DA 212/2015 - RESPONSE TO AMA SUBMISSION, SHADOW IMPACT AND BASEMENT DESIGN FOR WASTE COLLECTION

EXPERT OPINION
OVERSHADOWING IMPACT
500-520 Pacific Hwy St Leonards
17 October 2016

Figure 1: View from the sun at 11am, June 21

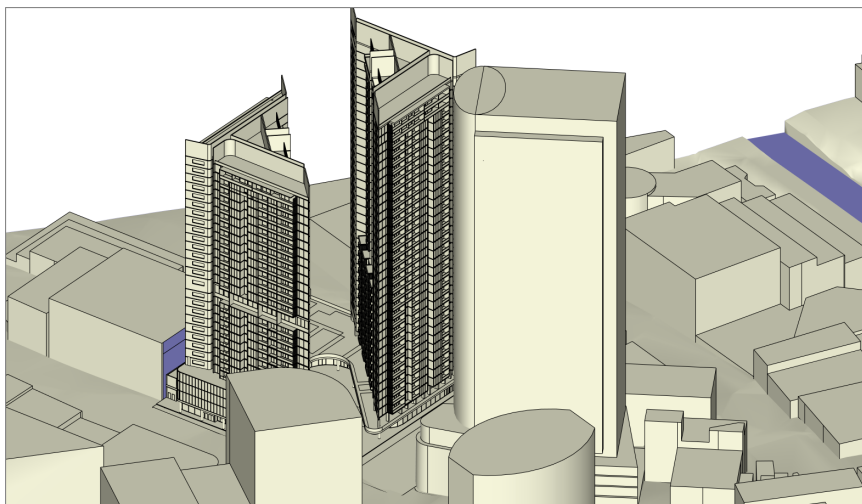
Importantly, the compliance reporting for the 'Mirvac development' at all times took into account the potential redevelopment of the 500-520 Pacific Hwy site, by way of inclusion of an approvable building envelope. Figure 1 illustrates the model showing the assumed building envelope in the centre foreground.

The overshadowing impact of this prospective development (now known as 'The Landmark') was critical in assessment of solar access for all apartments which rely on the north-west façade of 'Building B / Tower 2' of the Mirvac development.

Figure 2: Combined model. View from the sun at 11am, June 21

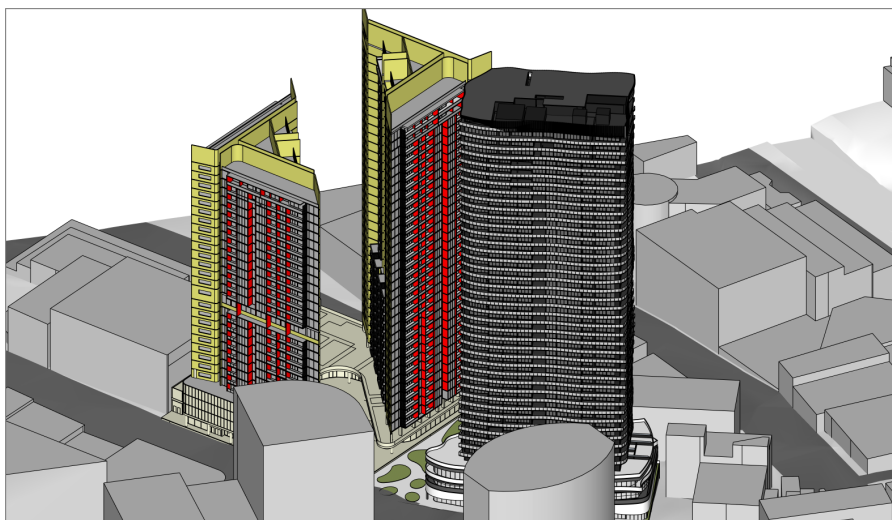
To calibrate the models, we rely on the latest DA plans for 'The Landmark'. We have located the 'Landmark' model by rotating it so that the faces of Mirvac building and Landmark meet along Friedlander Place, then positioned the rear of the carpark to meet the rear corner of Mirvac building.

There is a discrepancy in the nominated RL for Friedlander Place in the two models. Relevant figured RLs are 89.50 for Mirvac and 88.85 for Landmark. We have resolved this by lowering Friedlander Place by 650mm from Mirvac's ground level.

Figure 2 illustrates the combined model. I note that while the small RL anomaly may need checking for other coordination purposes, the relative heights of the two building models are actually not critical to my present analysis.

Figure 3 is a partial plan of a typical floor of that building, identifying the key units:

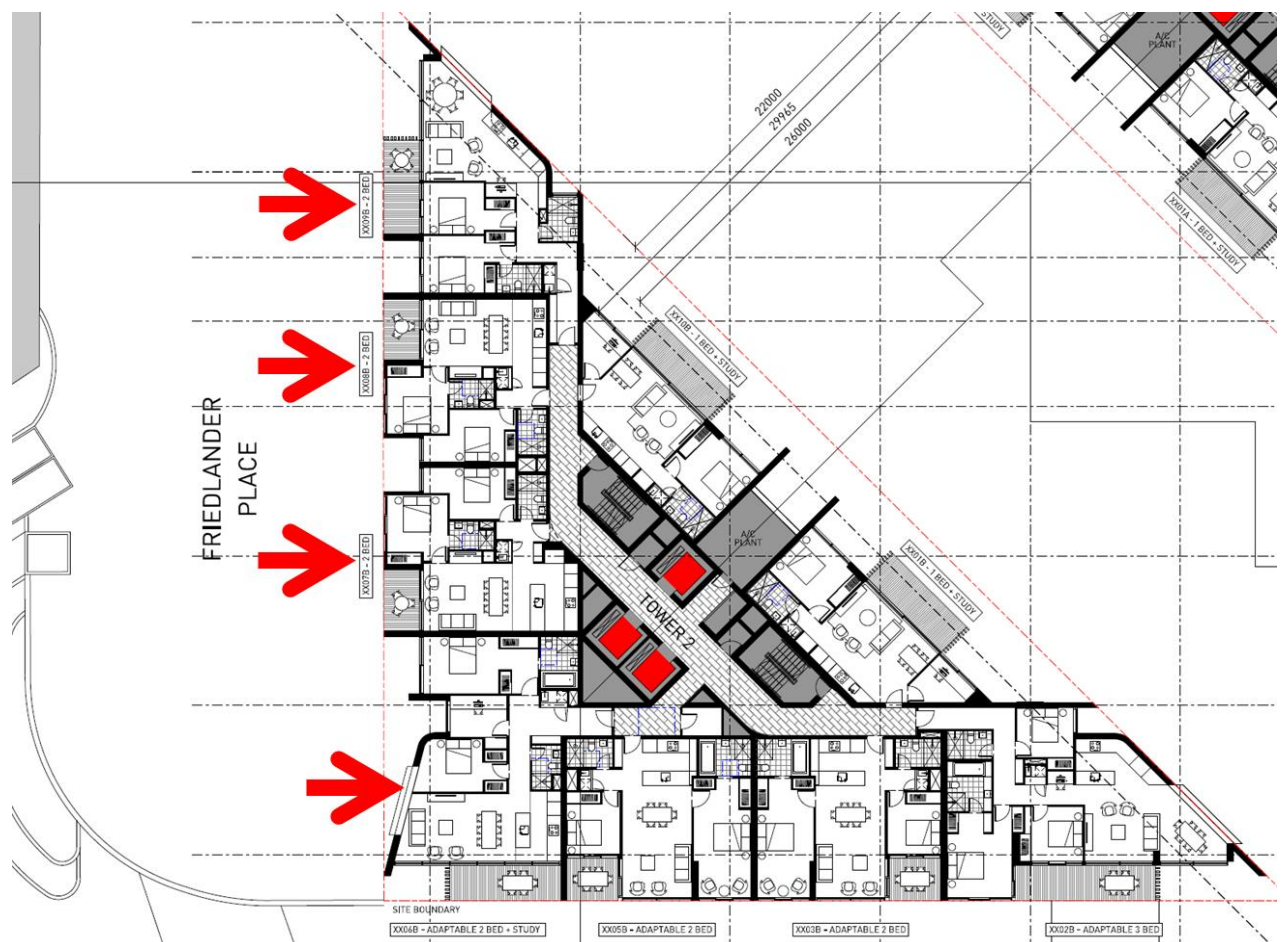
- Unit XX06 is previously reported as non-complying for minimum 2 hours under the ADG.
- Unit XX07 is reported previously as complying under the ADG with direct sun to glazing and POS for over 3 hours.
- Units XX08 and XX09B are reported previously as complying under the ADG with direct sun to glazing and POS for over 2 hours.

1000			
1030			First overshadowing impact. Because projected envelope for #500-512 assumed a curved east elevation, the impact of the subject scheme is very slightly greater on the glazing of the SW corner apartments in the Mirvac development.

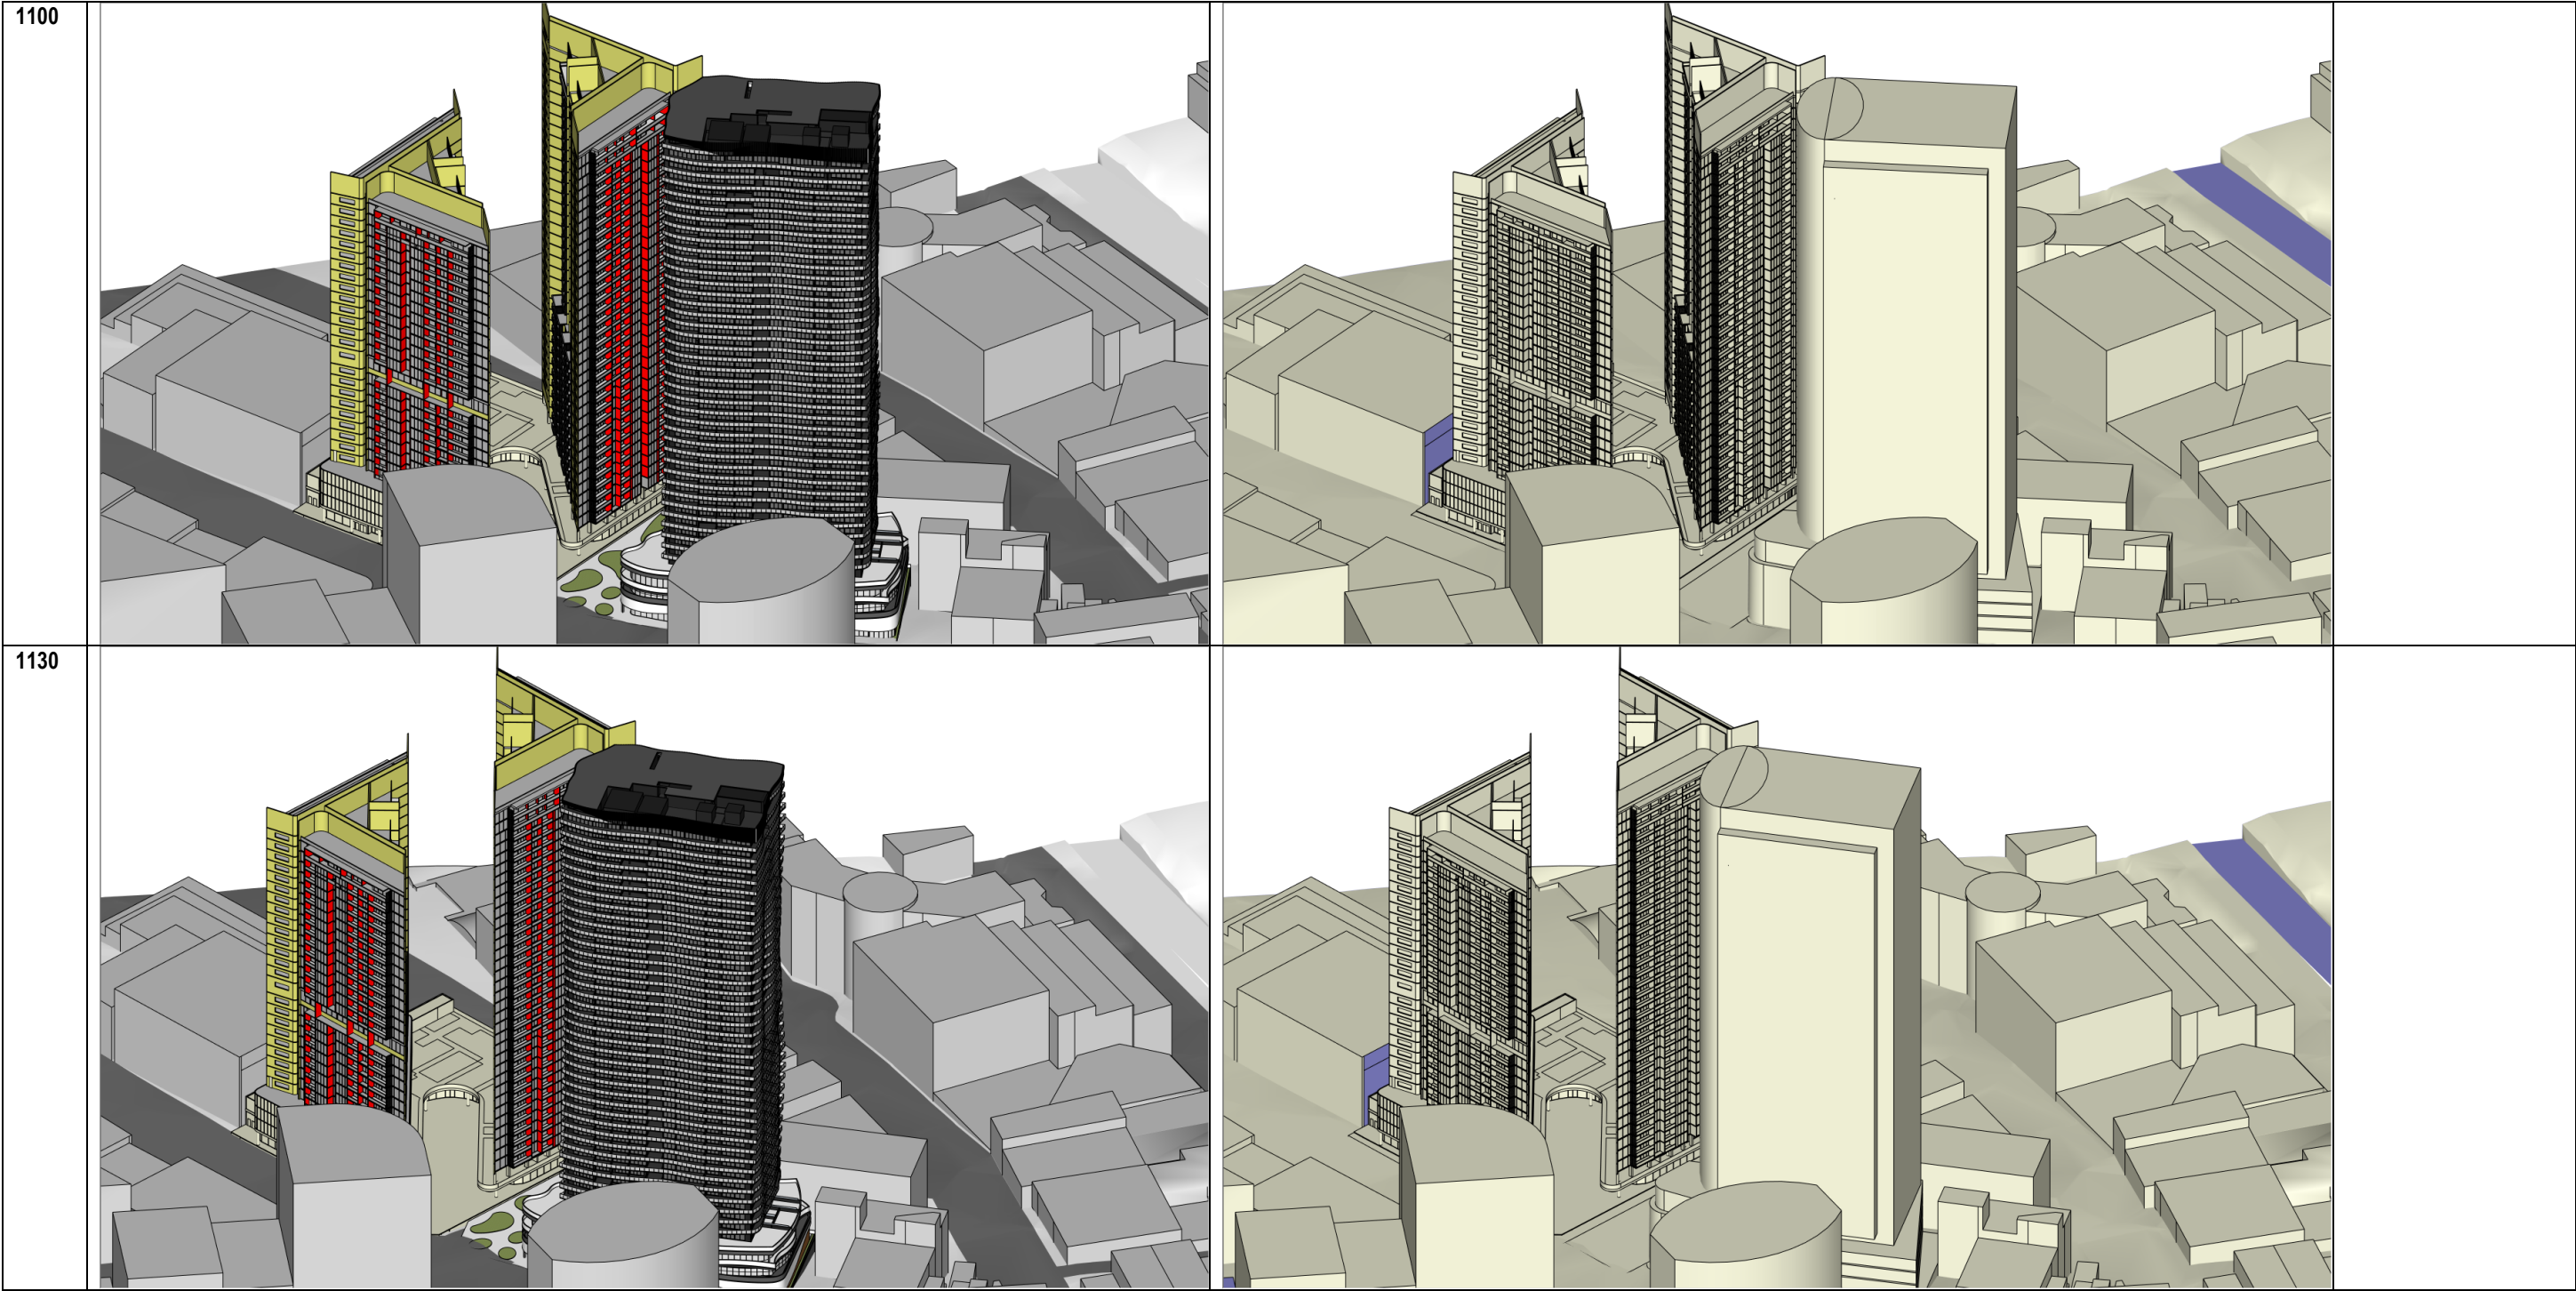
First overshadowing impact. Because projected envelope for #500-520 assumed a curved east elevation, the impact of the subject scheme is very slightly greater on the glazing of the SW corner apartments (Units XX06B) in the Mirvac development.

Ramp Section A
A
1 : 200

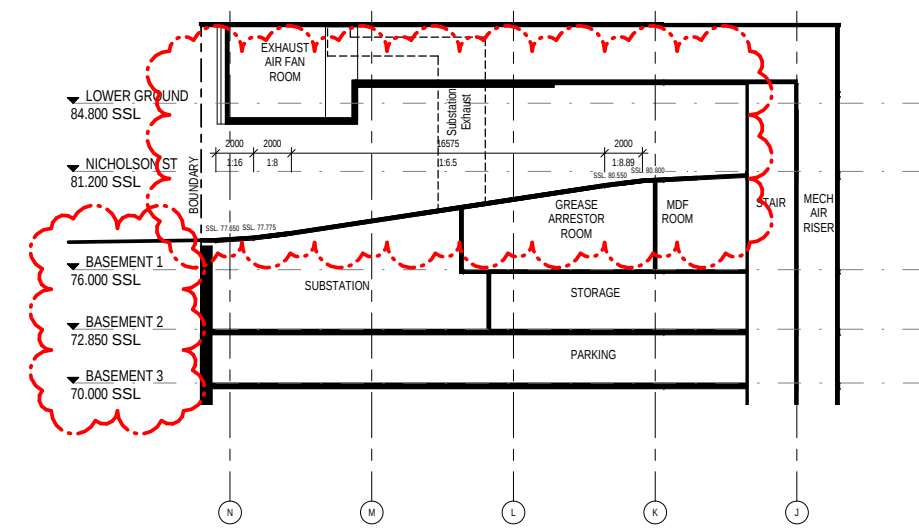
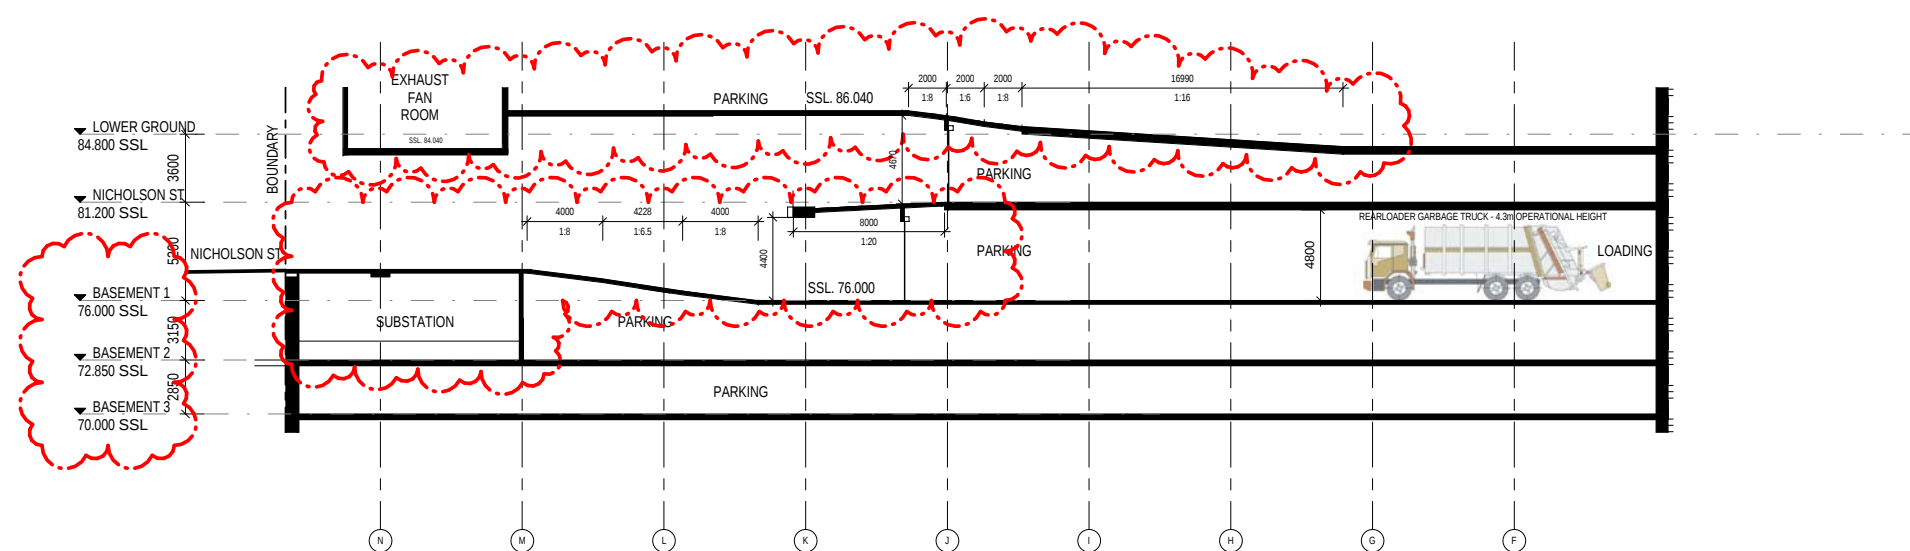
It is understood that Council will not accept a private contractor for on site waste collection. Currently the basement design does not adequately address Council's DCP Part Q which stipulates the required height clearances for travel paths and collection areas for Council's garbage vehicles.

Council has been provided with sketch plans showing how the basement design can achieve the required 4.3m height clearances for waste truck movement path and collection points, and has advised via email it is happy to condition the detailed design of the basement to provide for on site waste collection. As such, it is requested that a condition of consent be placed on any approval issued, requiring a finalised drawing reflecting this arrangement as follows:

Prior to issue of a Construction Certificate, the proponent shall provide to Council a revised basement plan demonstrating a design that complies with Council's DCP Part Q in respect to travel paths and collection areas for on site waste collection.
